<b>Docket Number:</b>	18-IRP-01
<b>Project Title:</b>	Integrated Resource Plan
<b>TN #:</b>	228874
<b>Document Title:</b>	Staff paper - Review of Modesto Irrigation District 2019 Integrated Resource Plan Filing
<b>Description:</b>	N/A
<b>Filer:</b>	Harinder Kaur
<b>Organization:</b>	California Energy Commission
<b>Submitter Role:</b>	Commission Staff
<b>Submission Date:</b>	6/28/2019 9:40:06 AM
<b>Docketed Date:</b>	6/28/2019

# **Review of Modesto Irrigation District 2019 Integrated Resource Plan Filing**

June 2019 | CEC-200-2019-008

**Figure 1: Modesto and Energy Commission Energy Forecasts 2018-2030 (GWh)**

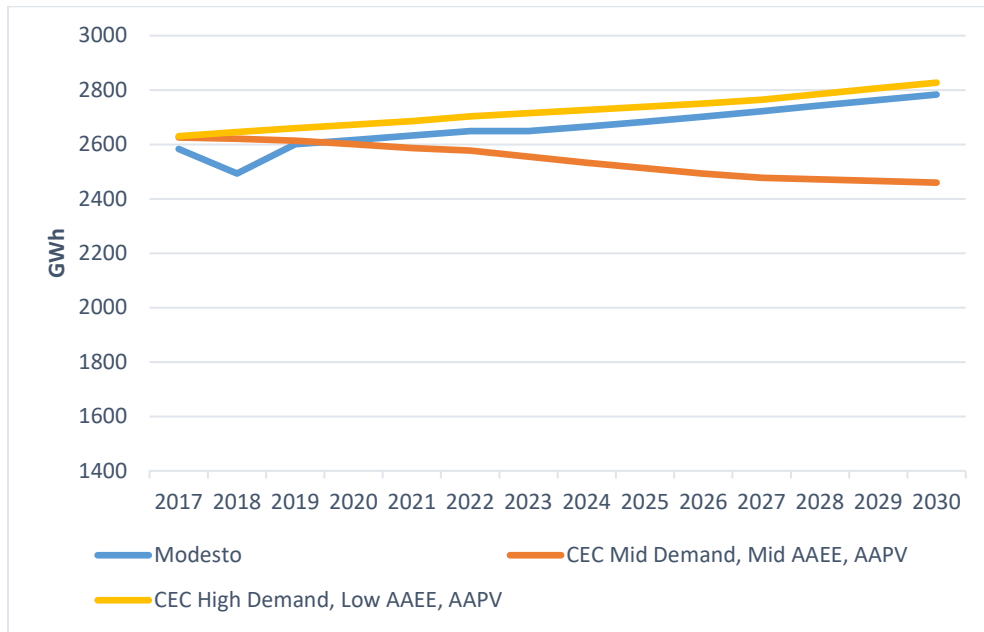
Modesto's net energy demand forecast shows an annual growth of 0.9 percent from 2018 to 2030. The annual energy growth rate was -0.2 percent from 2008 to 2017. The energy forecast growth is mostly due to the regional economic recovery after 2014. The Modesto forecast is comparable to the Energy Commission's forecast, falling within the range of the mid demand case and the high demand case, as shown in **Figure 1**.<sup>6</sup>

**Figure 2: Modesto and Energy Commission Peak Forecasts 2018–2030 (MW)**

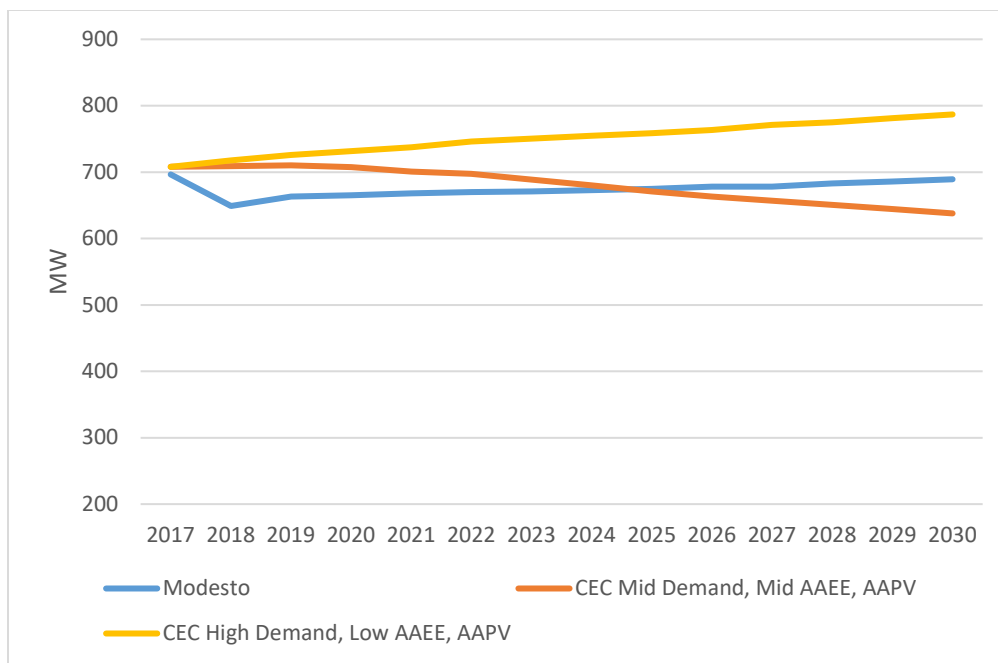
The Modesto peak demand forecast has an annual growth of 0.4 percent from 2018 to 2030. The annual peak demand growth from 2008 to 2017 was low at 0.8 percent, largely because of slower annual growth in demographic variables. The peak forecast is in the range of Energy Commission’s mid demand and high demand cases, as shown in Figure 2.

The differences between Modesto's and the Energy Commission's forecasts could be because of differences in modeling methods, since the Energy Commission's forecasts uses an end-use forecast, and Modesto uses an econometric forecast. Another potential source of the difference between Modesto and the Energy Commission forecast could be how additional achievable energy efficiency (AAEE) and additional achievable solar photovoltaic are calculated and incorporated into the models.
